RAINIER SQUARE REDEVELOPMENT RECOMMENDATION MEETING

Design Review Submittal

Address: 1301 5th Ave., Seattle, WA 98101

DPD Project #: 3017644

Current Proposed Tower with No Setback - **73.5%** Visibility

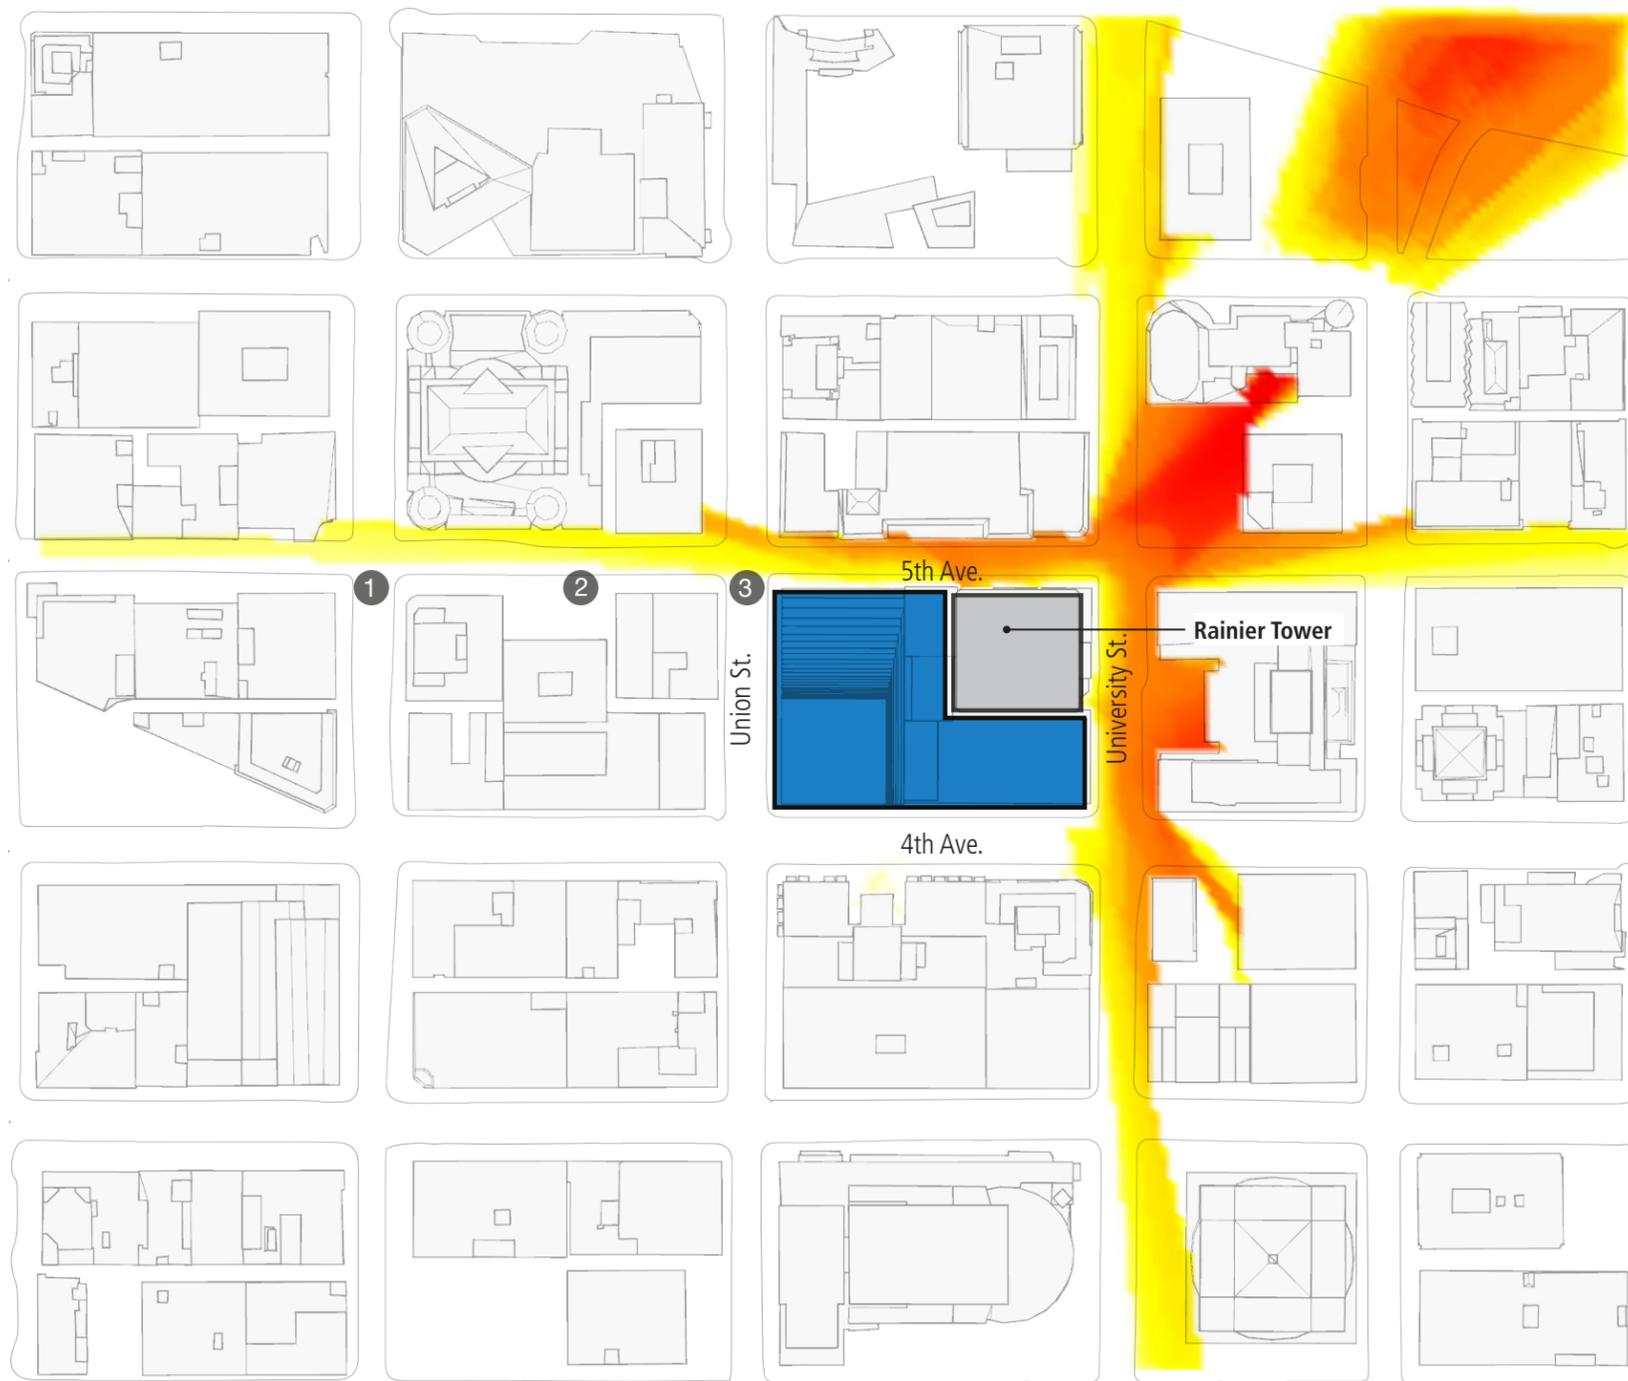
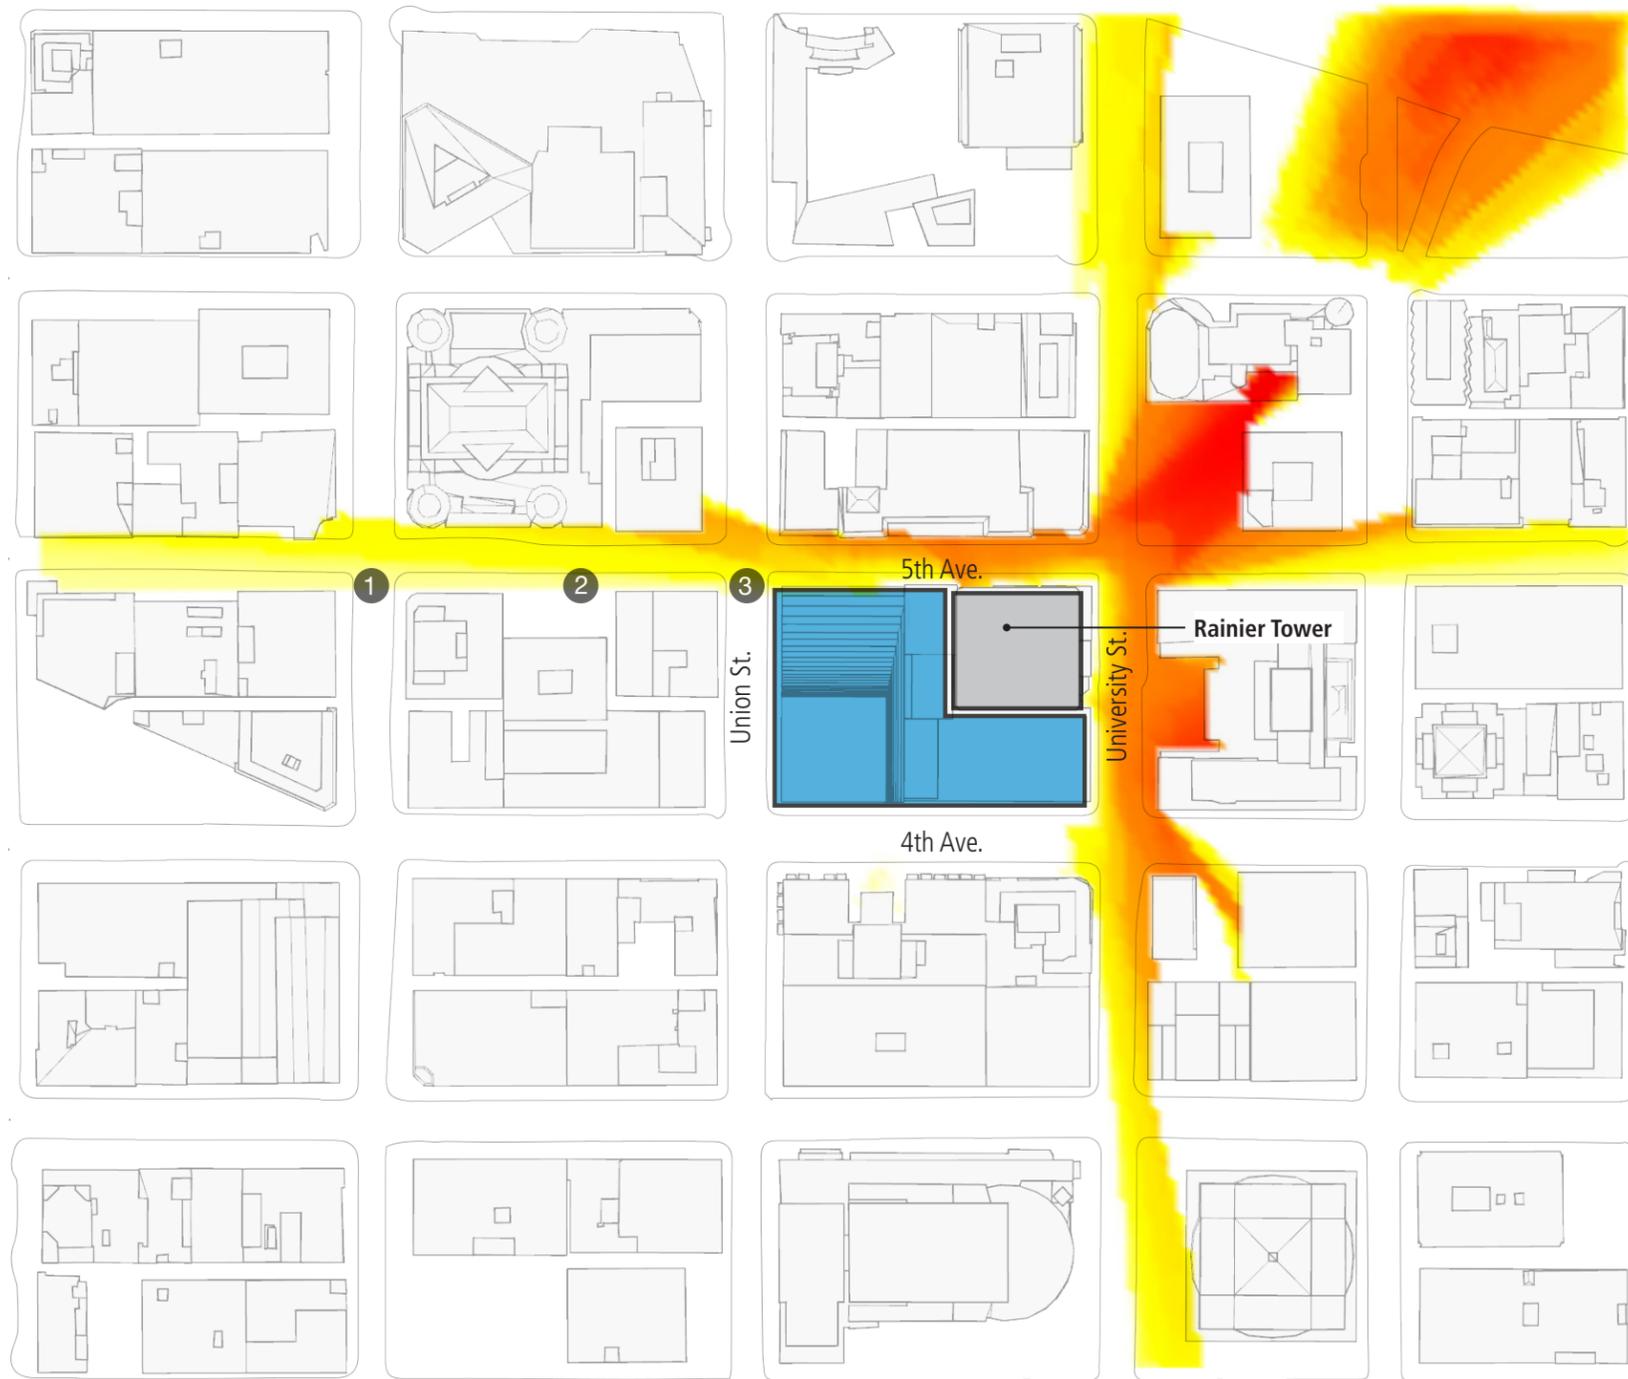
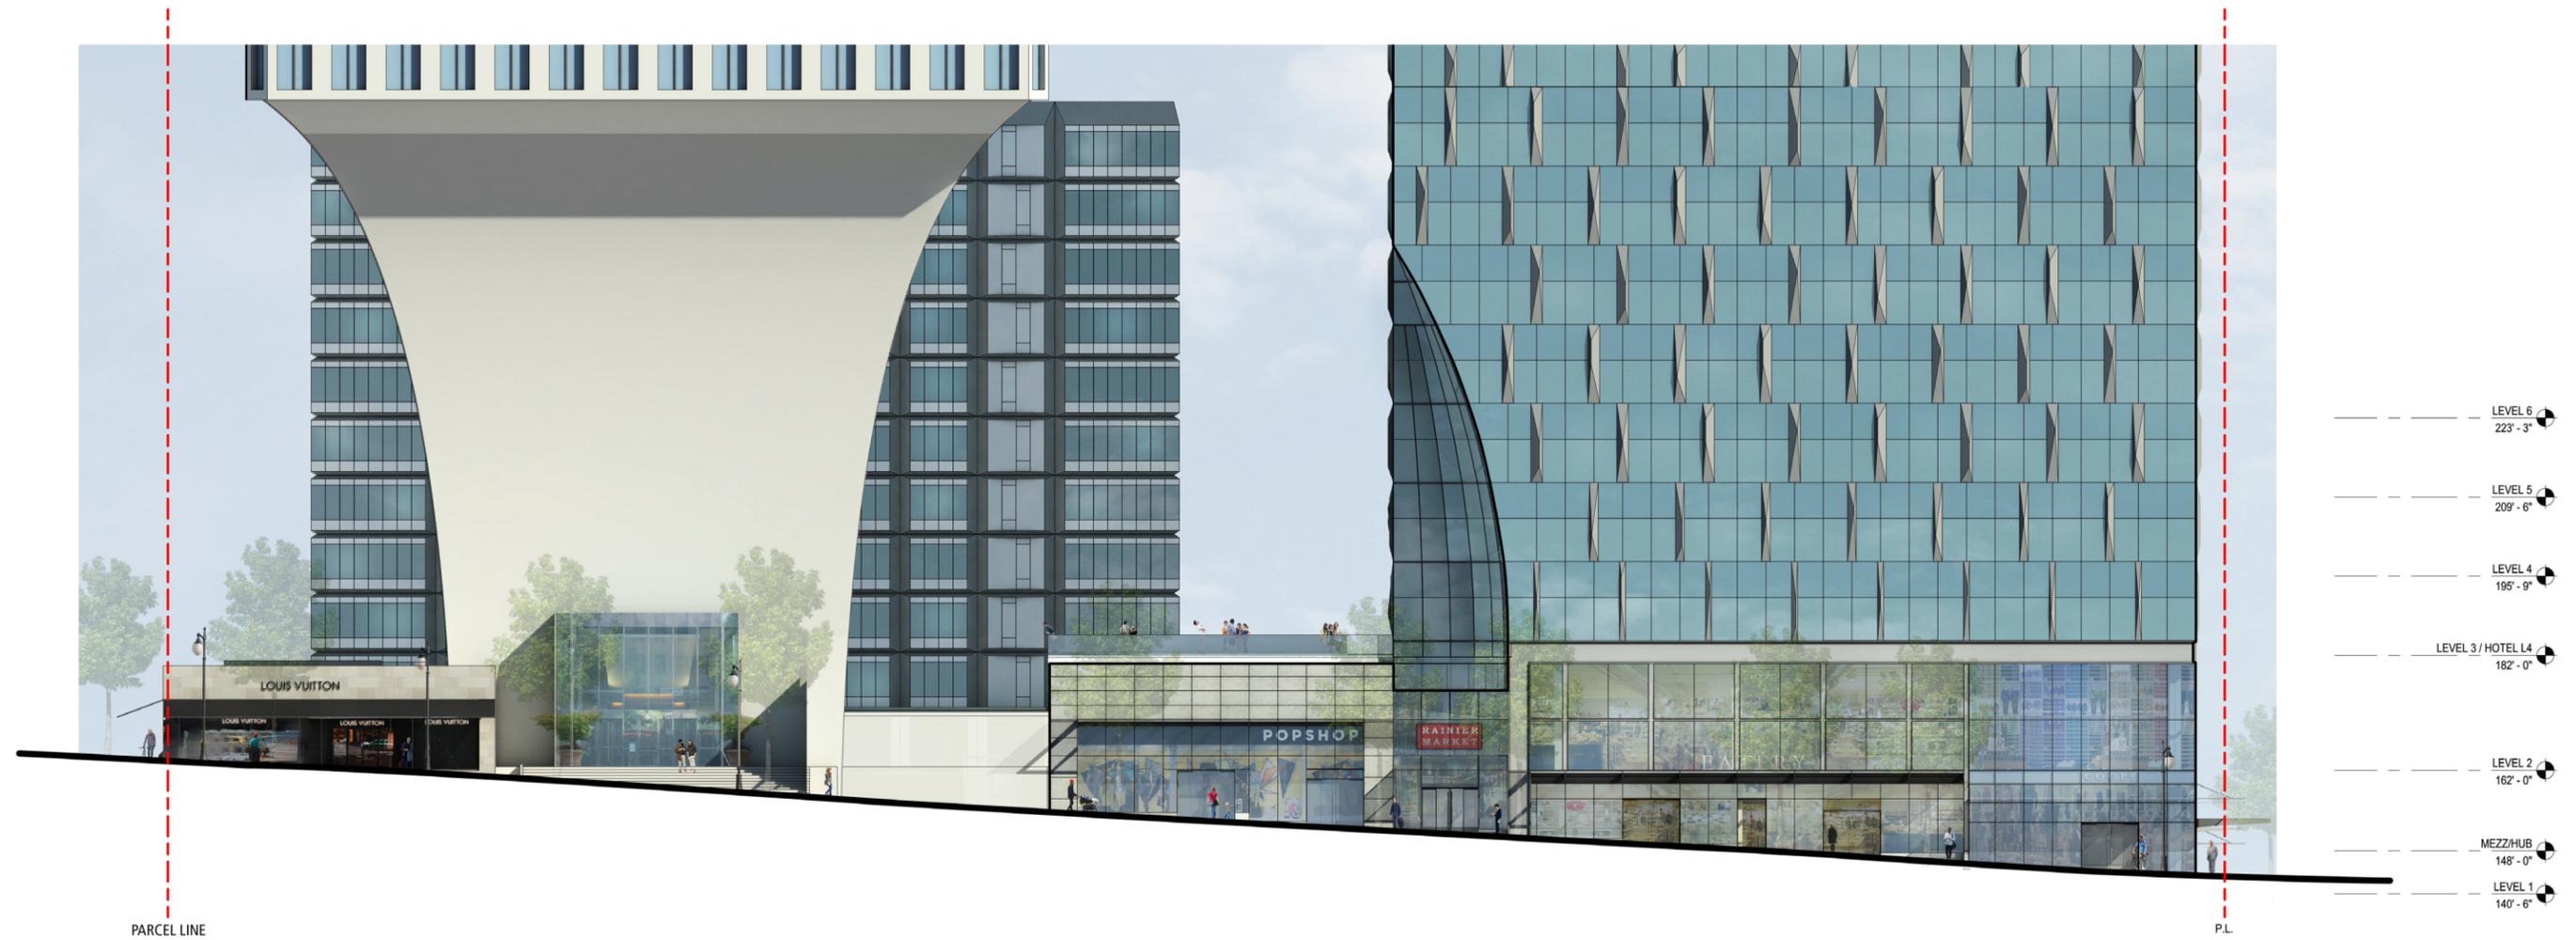
Item #1 - Please respond to the Downtown Board's request from the 2nd Ave.* base to open views to the Rainier Tower podium for drivers and pedestrians approaching from the north. If the preference is to retain the ten-story wall at 5th Ave. as shown in the MUP plans, please develop a plausible alternative for staff's and the Board's reviews.

This series of diagrams represents how much of the base of Rainier tower is visible from any given spot. The adjacent map was divided into 40,400 points at the ground plane. The base of Rainier tower was divided into 144 points. Sight lines were drawn between each set of points (5.8 million possible sight lines) and tested to see if they intersected any of the surrounding site context. The angle of each unobstructed sightline to the base of the tower was calculated and applied as a factor to represent how the building is seen from an angle.

The maps below are colored to represent the total visibility score for each point in the 25 block area. Red is the highest level of visibility, only achieved where two sides of the base are visible. Oranges are the equivalent of seeing most of one side of the tower. Yellows represent being able to see some of the base of Rainier Tower. White signifies no available view of the base. These diagrams represent what would be an ideal viewing condition. They account for the topography and neighboring buildings, but do not include the visual obstruction of trees, canopies, signage, or utilities, which would further reduce the view.

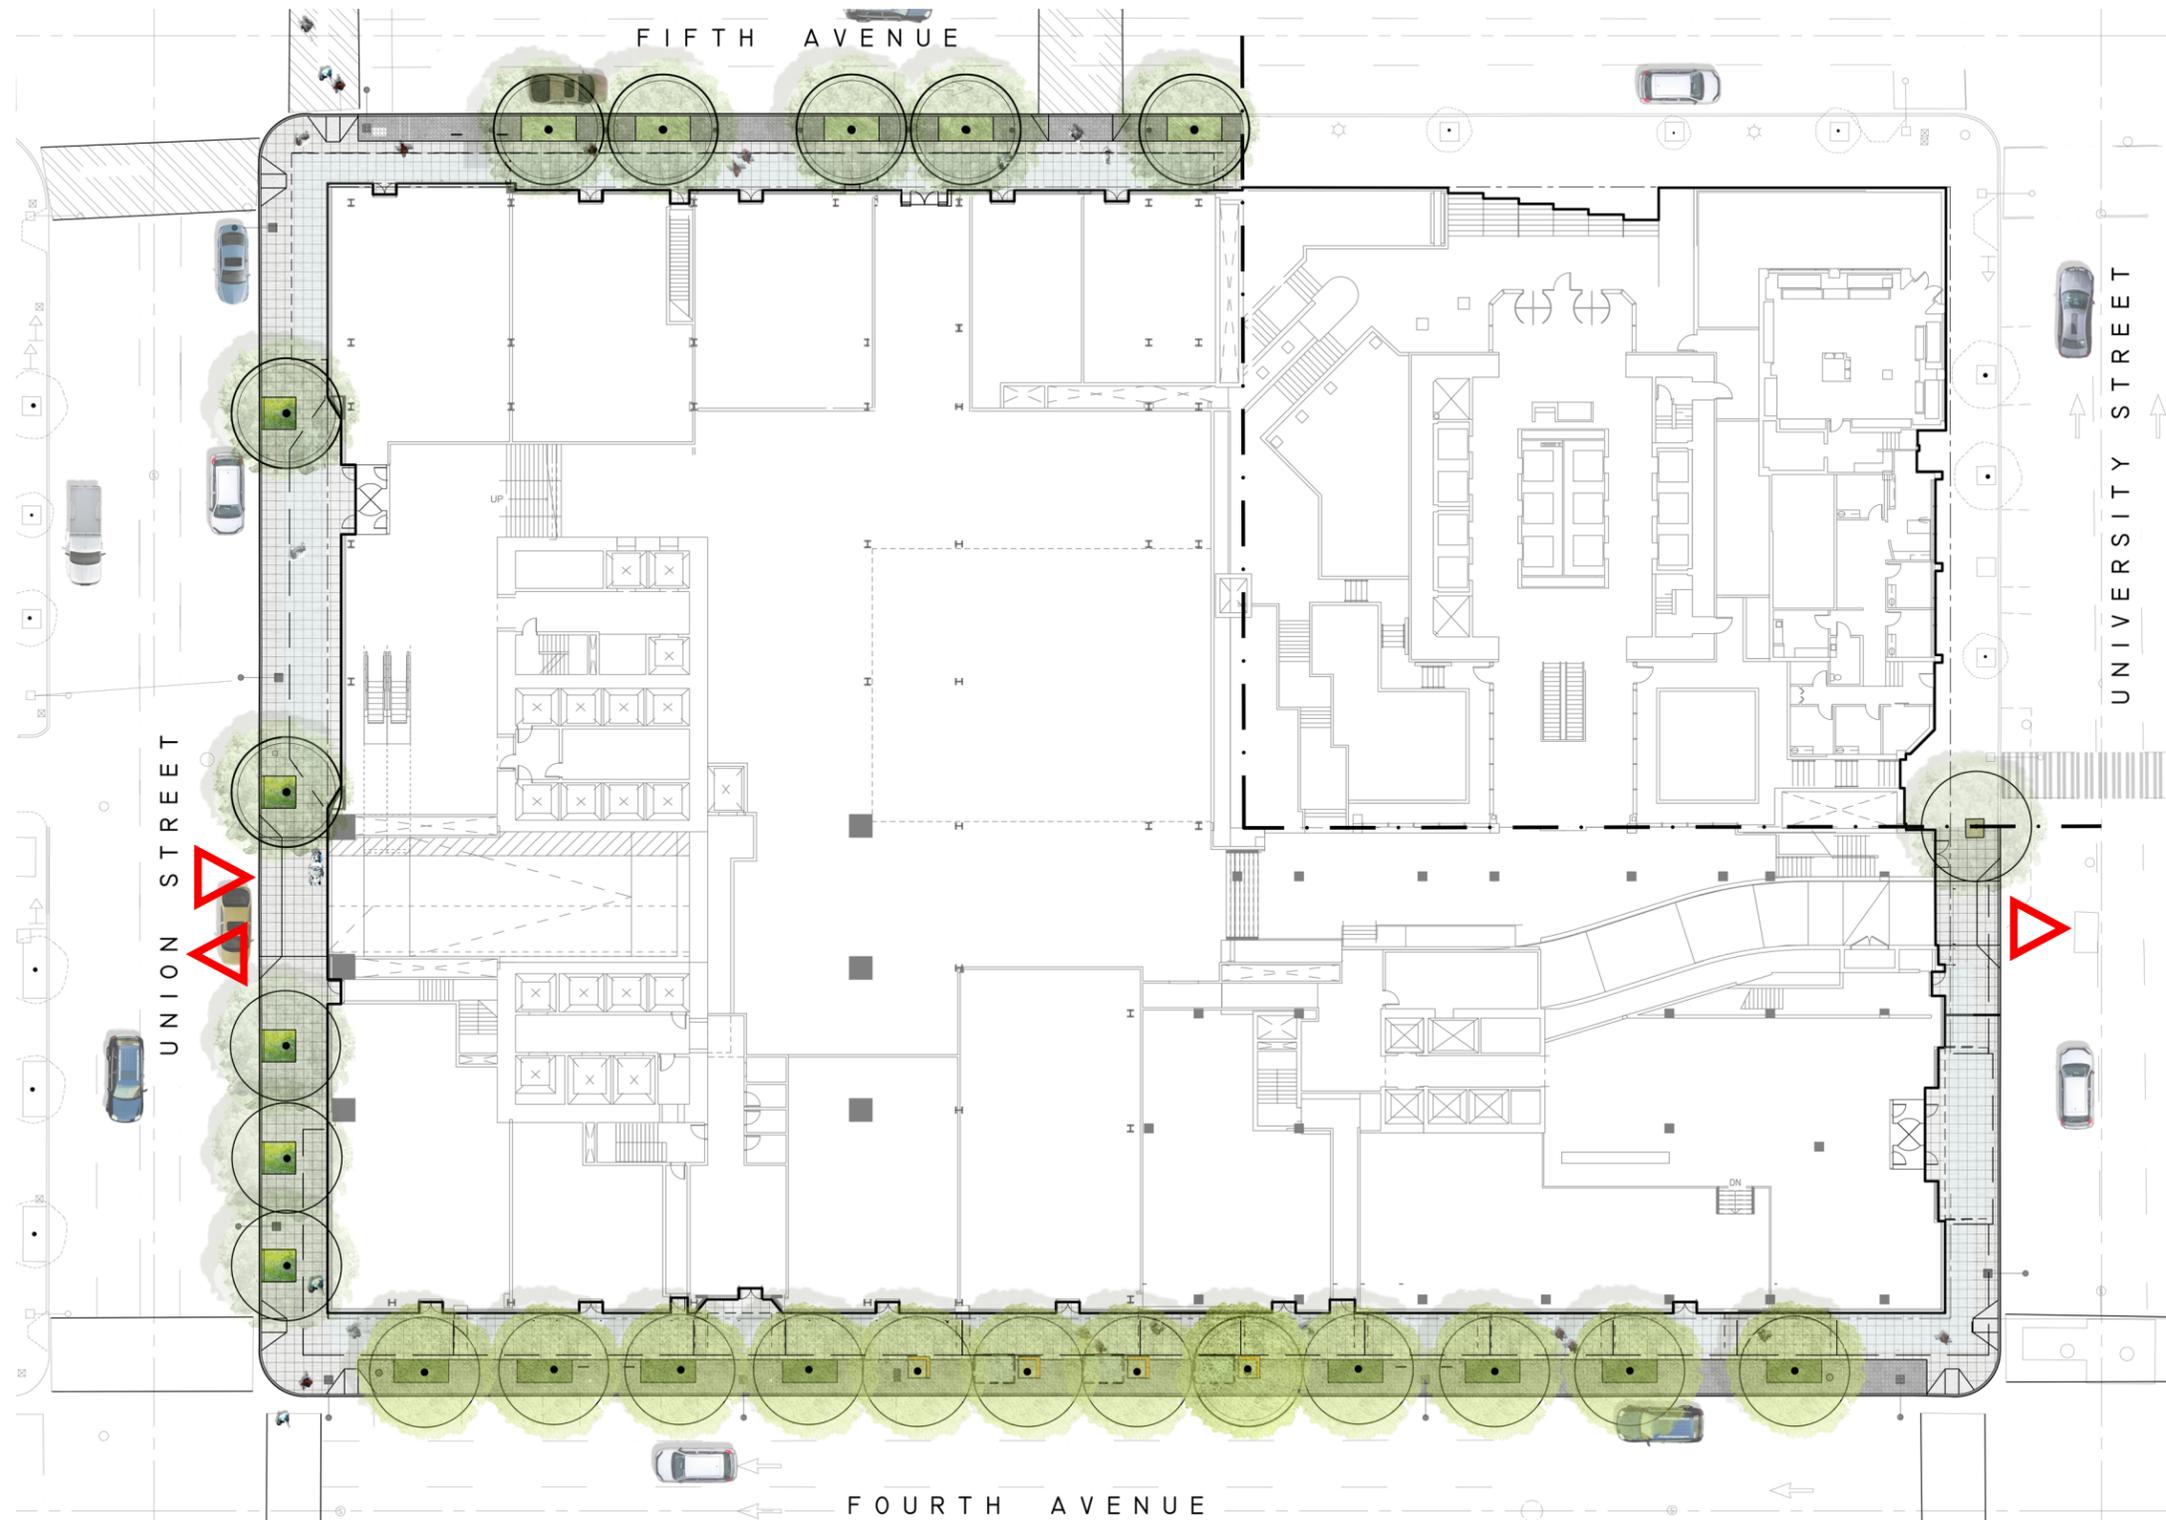
Item #8 - Landscaping. The landscape plans show different sidewalk concrete scoring patterns for the streets and the avenues. Please explain why they are shown to be different from the standard SDOT requirement (Plan set sheet L1-011.) It is also unclear why the sidewalk design doesn't match established precedent at Rainier Sq. or why it doesn't possess the same dark borders as those across Fifth Ave at the Skinner and IBM buildings?

Item #9 - Given the prominence of the project's location, consider landscaping the right of way to be more inviting and interesting. Staff urges the applicant to create ROW landscaping that approaches the quality of the city's green streets.

- Item #8
- Site paving is designed to better connect with the existing downtown sidewalk fabric by integrating standard SDOT concrete scoring on avenues and slightly modified standard SDOT concrete scoring on streets. Also included in the site paving strategy is a performance paving zone that improves planting conditions within the right-of-way.

- Sidewalk Concrete Scoring: The standard SDOT concrete scoring is included on 4th and 5th Avenues as well as University and Union Street. In addition to the standard SDOT concrete areas, the paving design improves tree root zones by incorporating larger tree pits, rootways, and a band of porous paving along the curbside planting zone. The intent is to maximize this performance zone from back of curb to edge of planting.

- Item #9
- Established Precedent at Rainier Square: The current paving scheme at Rainier Square was not recreated as part of this project for the following reasons: (1) it reduces the amount of pervious area along the tree root zone and (2) this detail is specific to this block only and is not part of the larger city sidewalk network. We felt that it was important to tie back to the City standard concrete grid along the avenues and streets to better integrate the Rainier Square block into the city's sidewalk network.

- Dark Borders at Skinner and IBM Blocks: The dark curb band detail seen at the Skinner and IBM buildings was not included for two reasons: (1) it reduces the amount of pervious area along the tree root zone area and (2) this detail is specific to the Skinner and IBM building blocks and is not part of the larger city sidewalk network.
